Product Change Notification

MODULAR CONTACTS

Model 70AA/Male and 70AA/Female Modular Contact Packaging Improvement

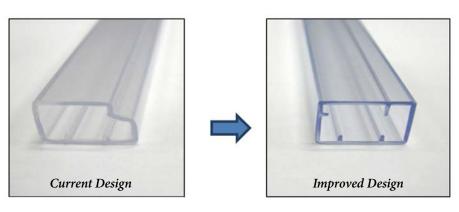
The Bourns Trimpot Product Line announces a new design layout for the tube packaging of the Bourns® Model 70AA/Male Modular Contact and 70AA/Female Modular Contact. The improved designs provide a more secure fit and increased stability of the products during the shipping and handling process.

We will begin phasing in this process: October, 2013
